Neil M Craigie Pty Ltd

24 December 2021

RE: WONTHAGGI NE PSP - PRELIMINARY DRAINAGE REVIEW

Figure 1 Engeny/Alluvium Proposal for WLRB1 lowflow outlet

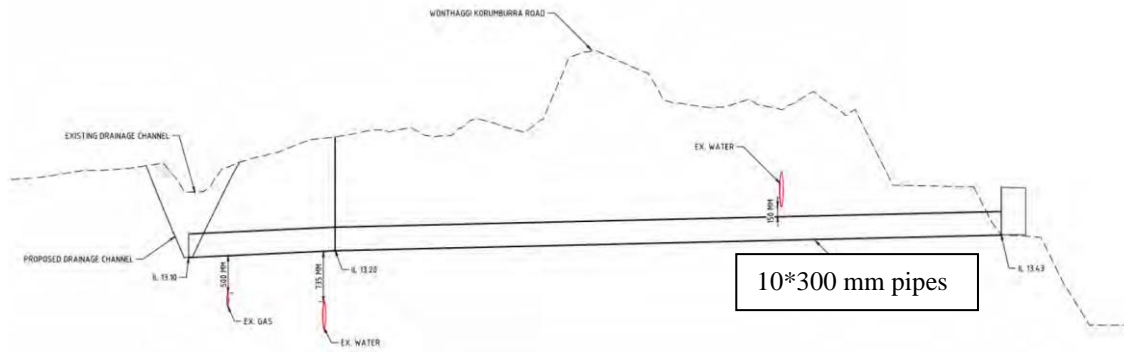
The current Alluvium low flow outlet design for WLRB1a+b reflects the Engeny proposal. It provides for 10*300 mm pipes (length ~100 m), to get under/over the gas main and the water mains. Figure 1 refers.

There will be inevitable operation and maintenance problems with this design. There are more practical and less costly arrangements available which should be considered in future design.

A quick check on the capacity of the designed outlet system at headwater level of 14.5 m (crest of the high flow outlet culverts under Wonthaggi Korumburra Road) shows that no more than 650 l/s can be discharged to the MOP outfall.

Figure 2 Suggested Alternative for WLRB1 lowflow outlet

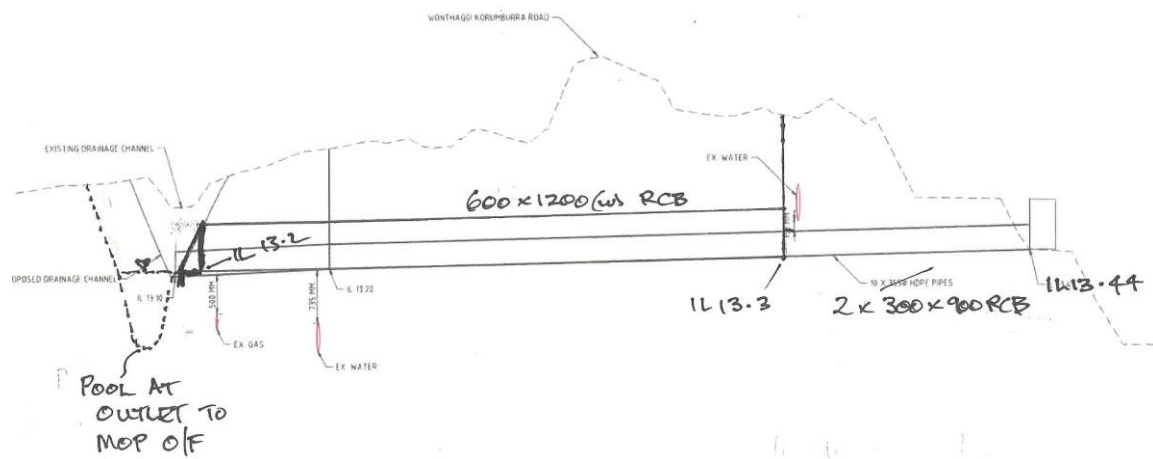
Figure 2 shows a suggested alternative that matches this capacity with a simple box culvert arrangement. A small pool should be added at the outlet end to the MOP outfall regardless of whatever design solution is adopted.
